Report from the Sydney Harbour HighLine Association to The Lavender Bay Rail Committee – March 2018

Sydney Harbour HighLine Association Report to Lavender Rail Line Committee – March 2018

The SHHL Association reviewed the Sydney Trains analysis dated 15th August 2017 that was released to the Association on 22nd December 2017. It now submits this Report outlining details of the SHHL based on the information available to it at this stage.

TITLE: **WAVERTON TO LAVENDER BAY
SHEET 6 OF 11**

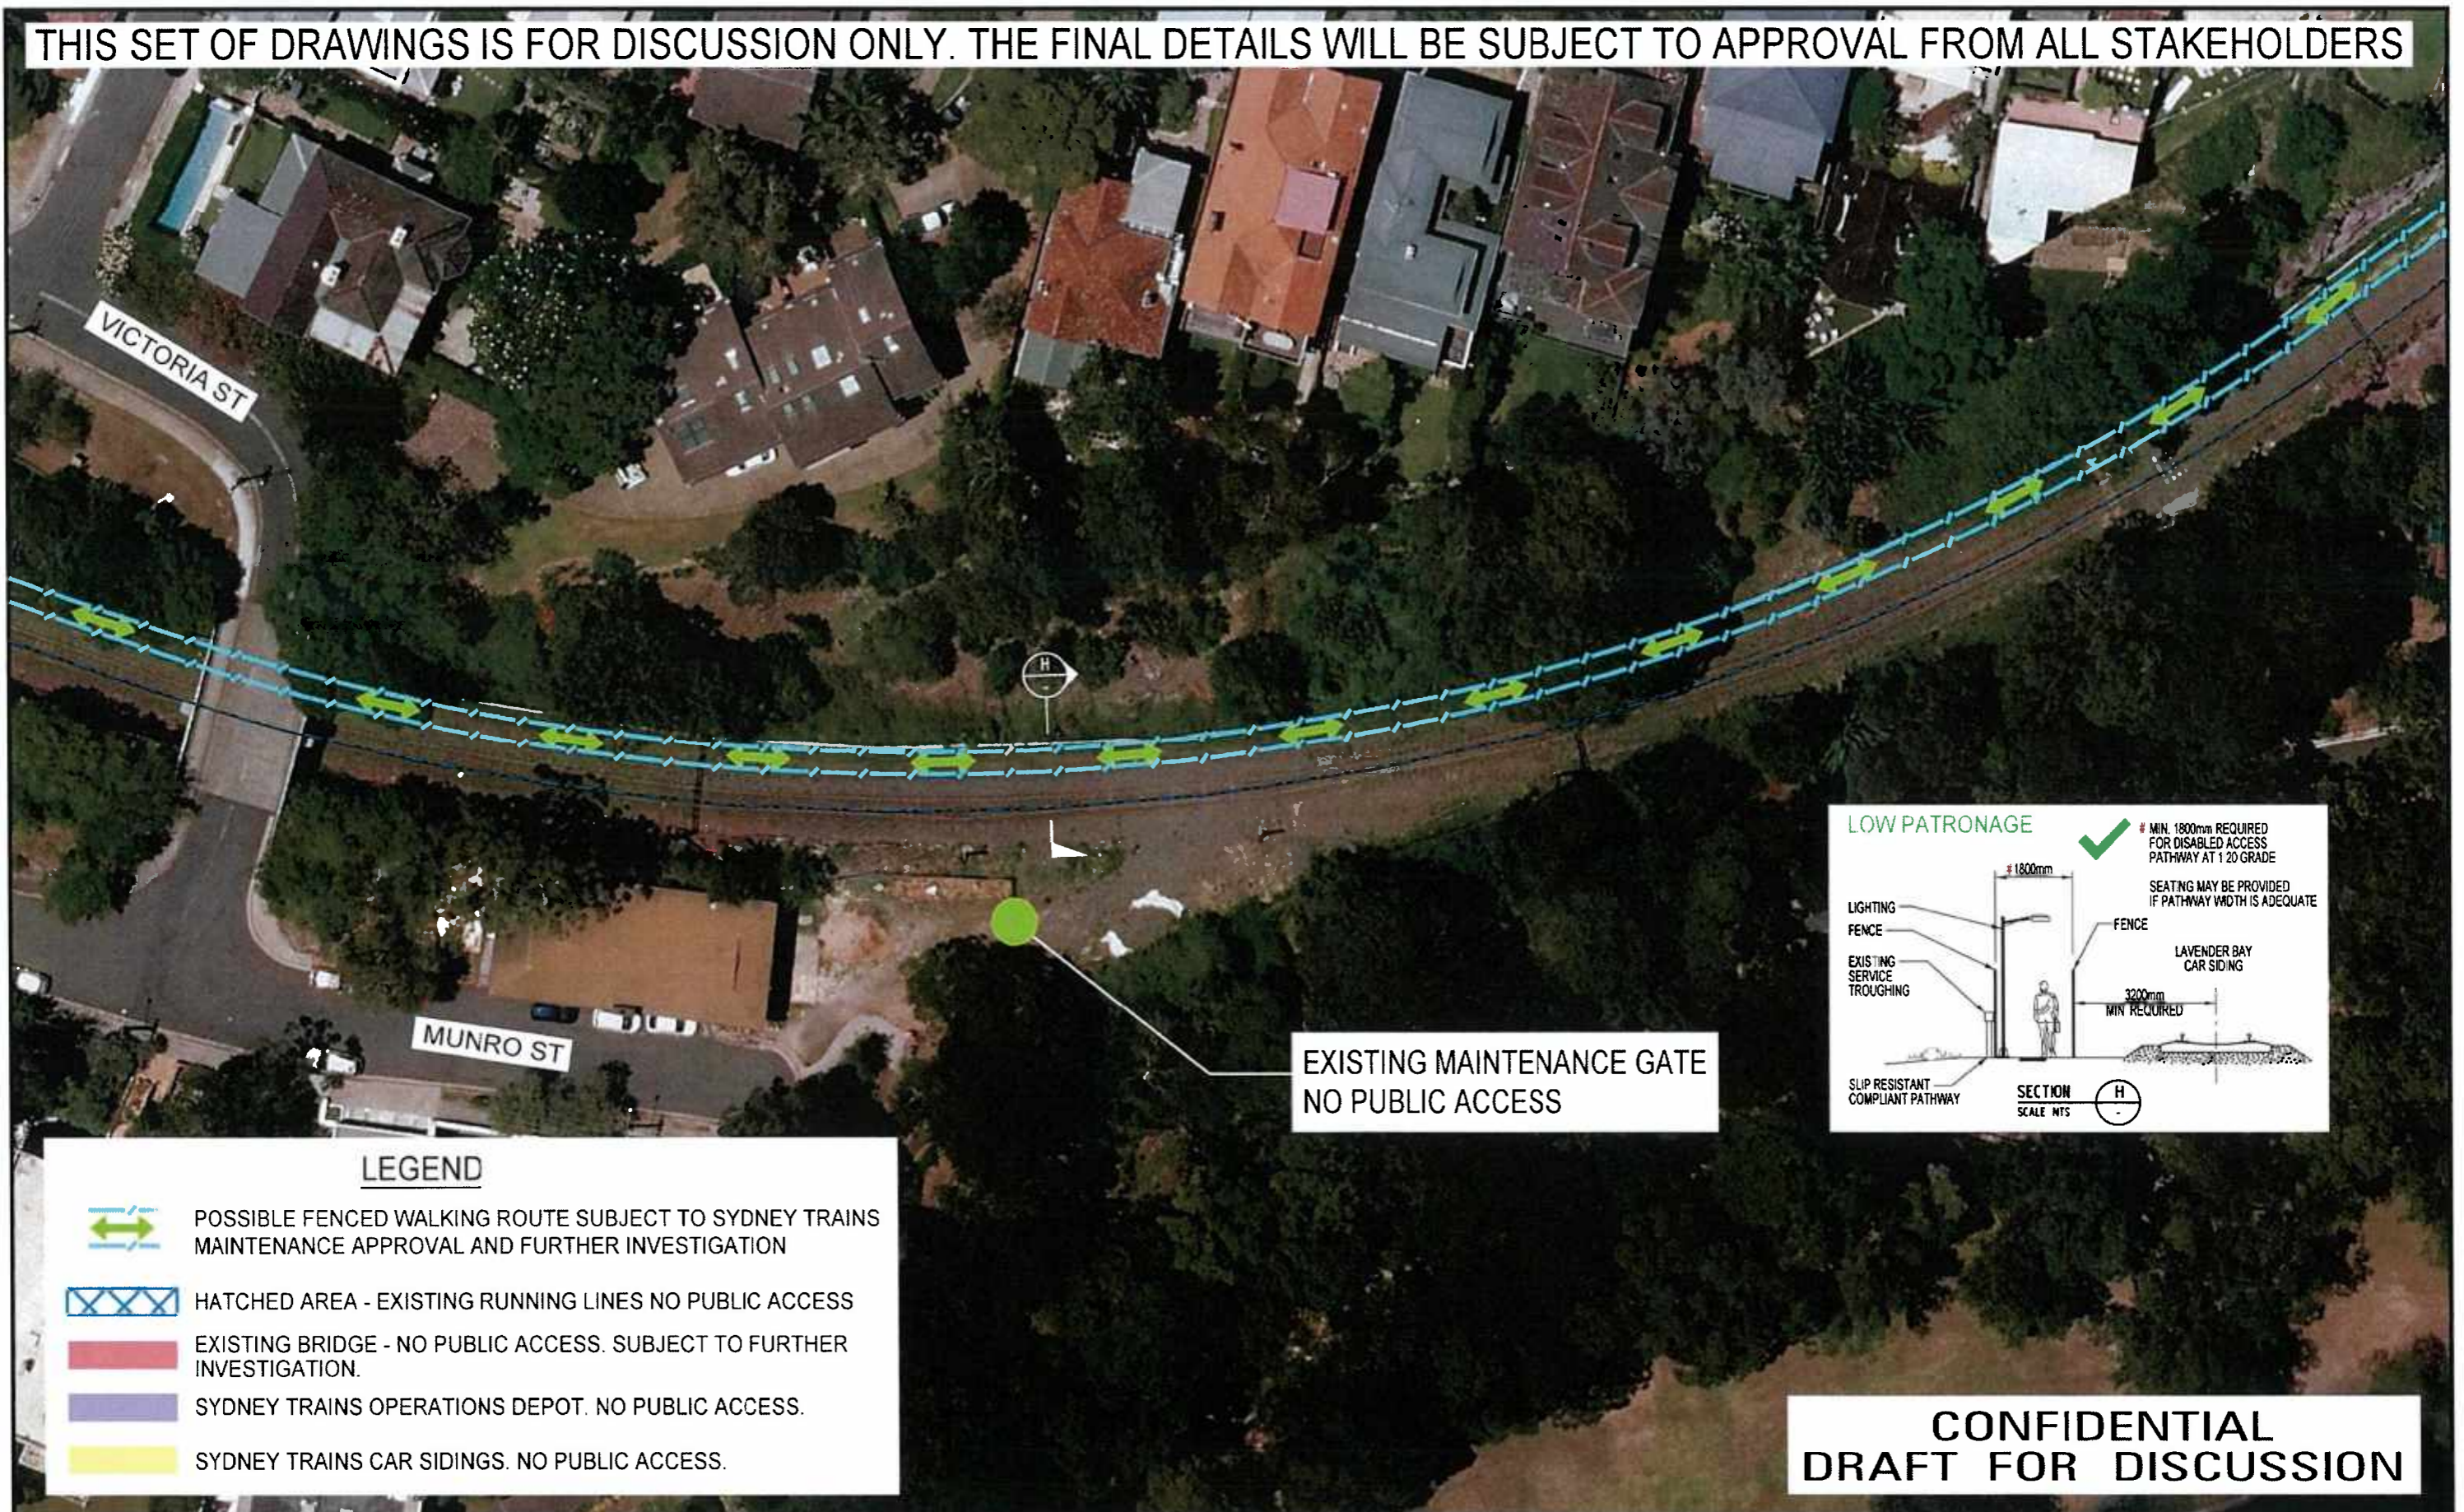
POSSIBLE ENTRY/EXIT POINT AND ACCESSIBLE RAMP AT CUTTING SUBJECT TO FURTHER INVESTIGATION. STREET ACCESS AT TUNNEL PORTAL NOT RECOMMENDED DUE TO STEEP GRADE.

TUNNEL ENTRANCE. ACCESS NOT RECOMMENDED DUE TO THE FOLLOWING ISSUES:
SAFETY
SECURITY
AIR QUALITY CONTROLS
EMERGENCY ACCESS
LIGHTING
DRAINAGE
POTENTIAL ANTI SOCIAL BEHAVIOR

POSSIBLE CONTAMINATION IN HATCHED AREA. FURTHER INVESTIGATION REQUIRED.

2.3.5 The Tunnel

Tunnel concerns expressed by Sydney Trains

Sydney Trains has raised concerns relating to the use of the tunnel by pedestrians:

- Safety
- Security
- Air Quality
- Emergency Access
- Lighting
- Drainage
- Anti-social behaviour

Safety

- The HighLine will be closed after dark, at least from Dumbarton Street to Wendy's Secret Garden.
- Sydney Trains' speed limit is 40 kms p/h; trains operate at less than this speed particularly in the tunnel.
- There will be a fence separating the rail line from the walking trail.

Security

- See safety (above) and lighting (below).
- CCTV will be installed along the length of the tunnel
- The tunnel meets the requirements of ASA 6.12 by providing a mid-rail to fence distance of 3 metres (there are no stanchions in the tunnel and the 3 metres set back conforms to the code).

Air Quality Control

- The advice to hand is that the natural ventilation of the tunnel meets applicable clean air standards.

- New drainage will be installed in conjunction with the pathway and fencing works.

**WAVERTON TO LAVENDER BAY
SHEET 10 OF 11**

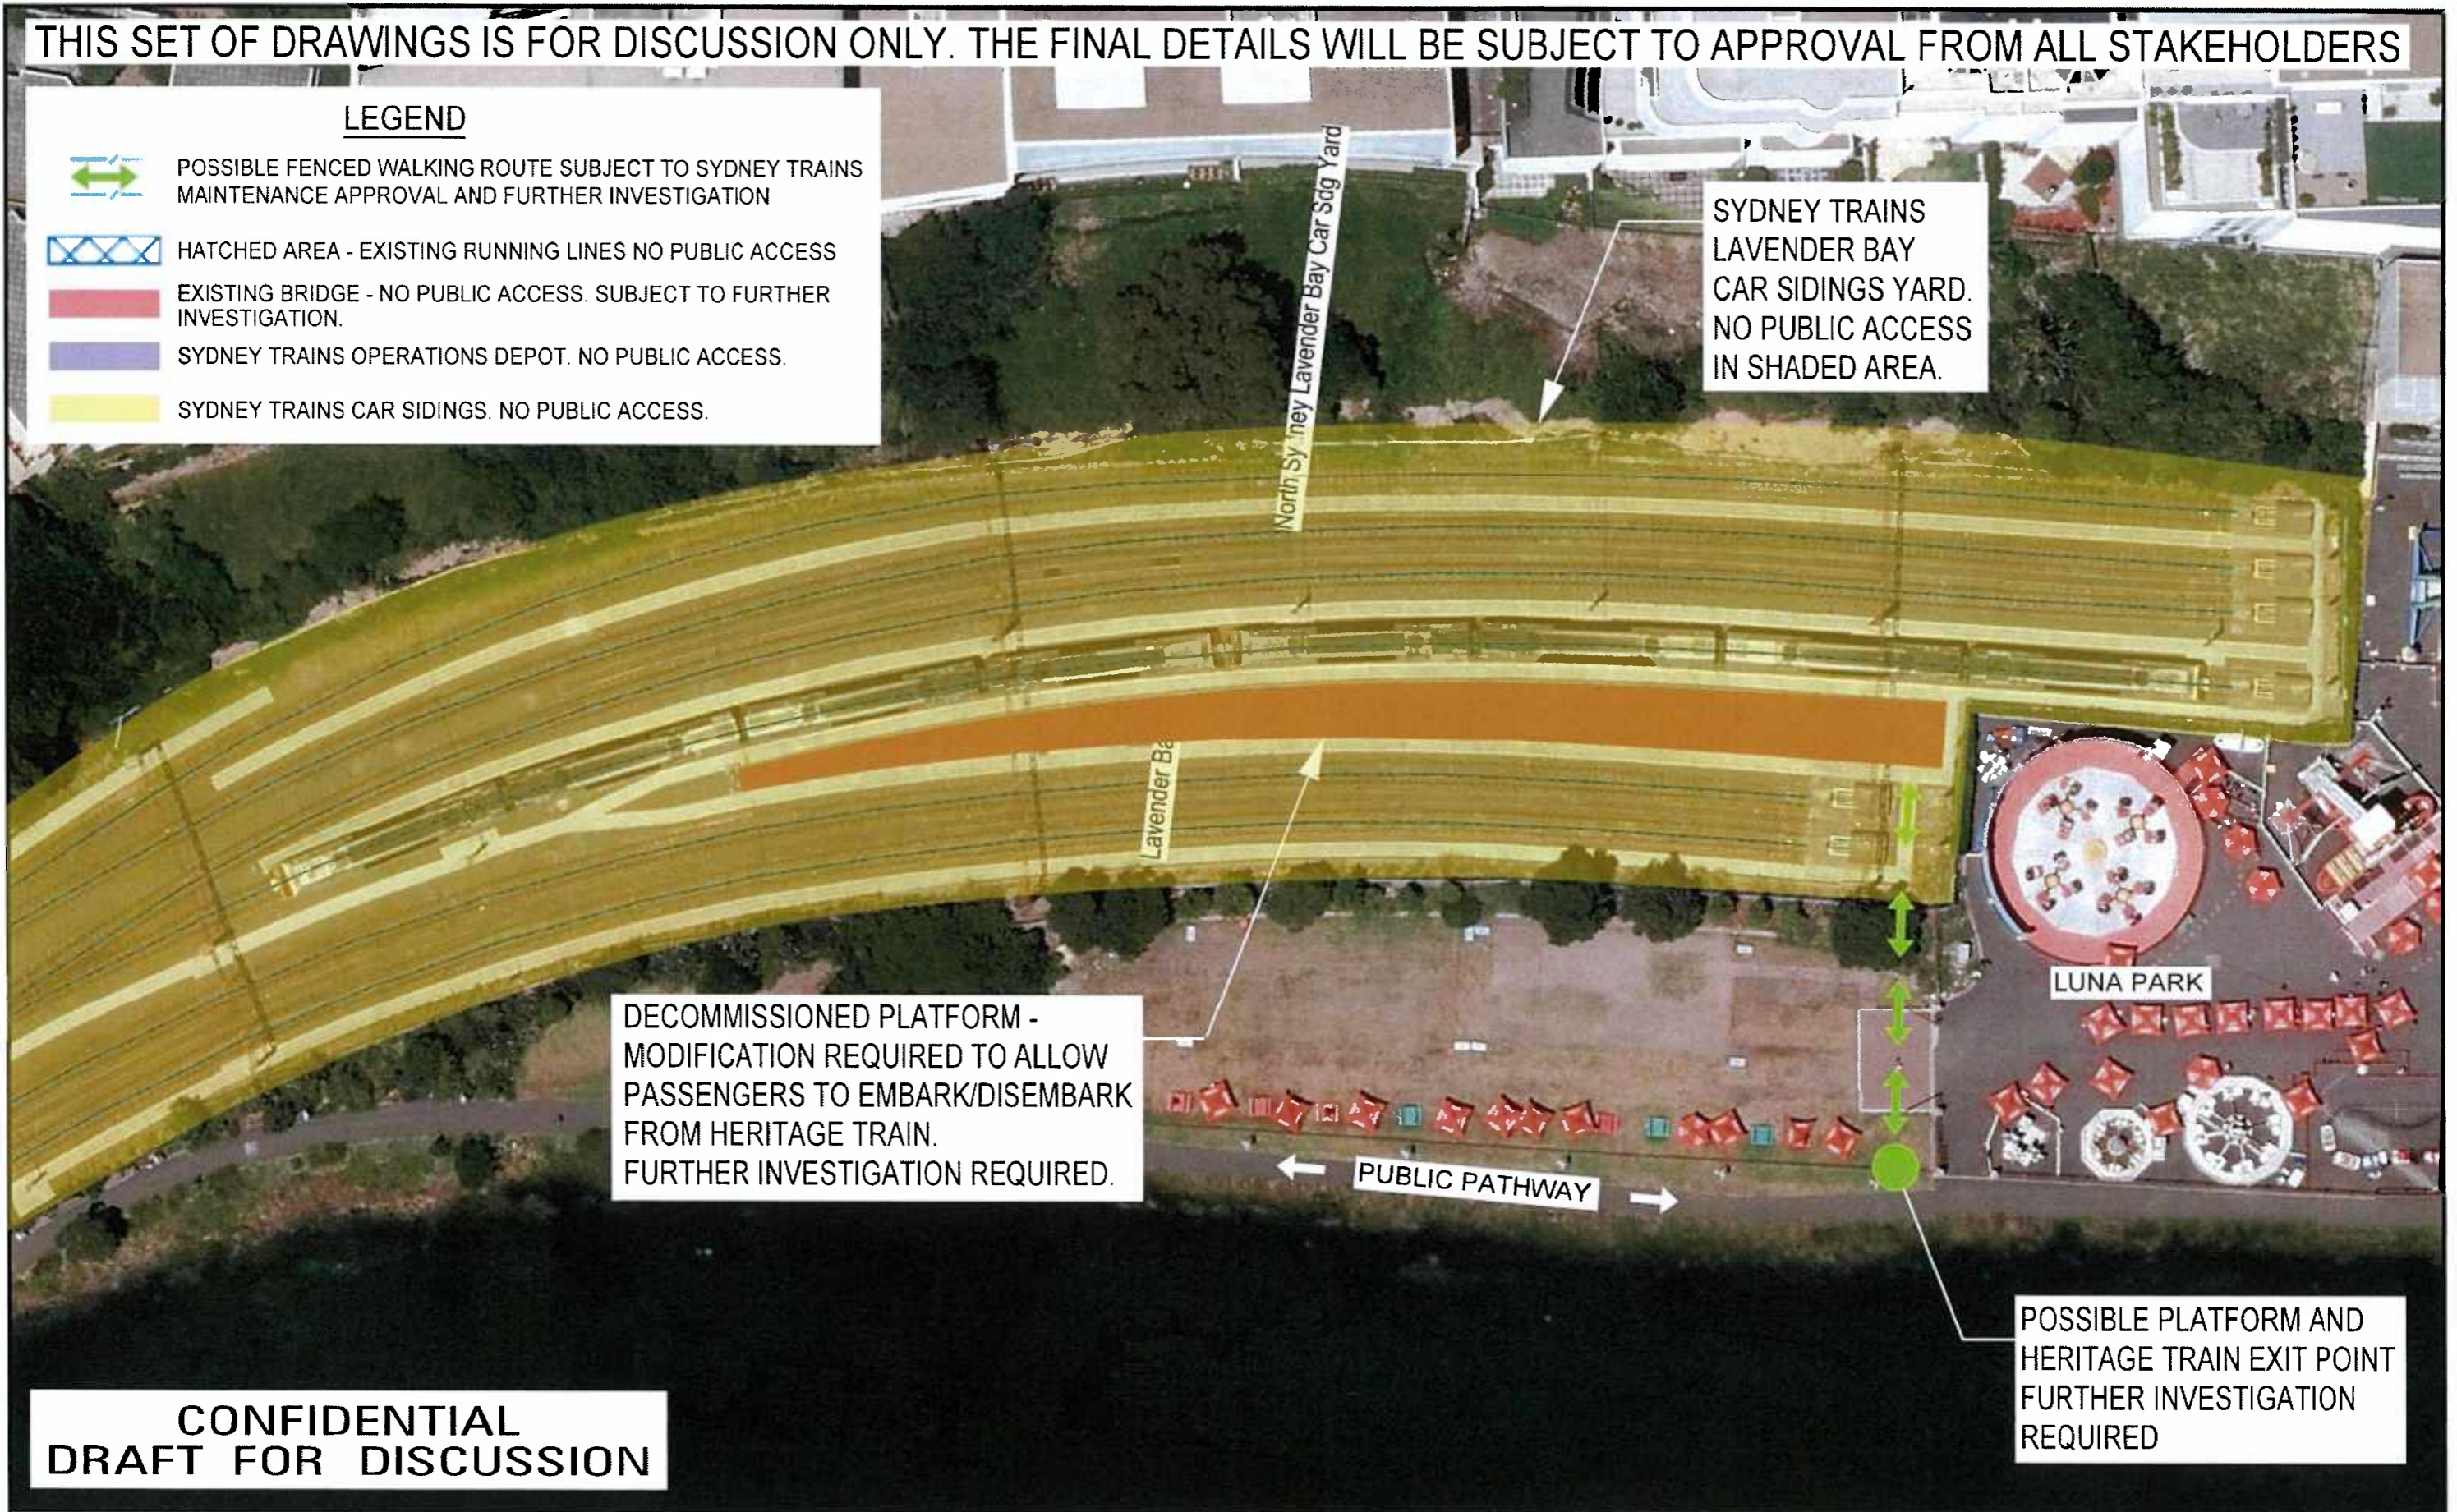
Reference 'Sheet 10'

Requirements, shared access pathway from street to Wendy's Secret Garden, lockable, with optional lighting if not currently available. Cost estimate required.

Reference 'Sheet 10'

Requirements, a dedicated pathway (hatched area) from street to Wendy's Secret Garden, lockable, with optional lighting if not currently available eliminating the need for stairs. Cost estimate required.

Sydney Trains has proposed the existing pathway from the Lavender Crescent entry to Wendy's Secret Garden be closed to the public. It is proposed that:

- this pathway be shared by the public and Sydney Trains.
- the vacant land immediately adjoining Wendy's Secret Garden and the Sydney Trains Depot be used for a café and amenities with access through to the Garden.
- The first stage of the HighLine walking path would then commence/terminate at this point. The second stage will commence from this location when Sydney Trains allow access to the corridor currently occupied by Line 6.
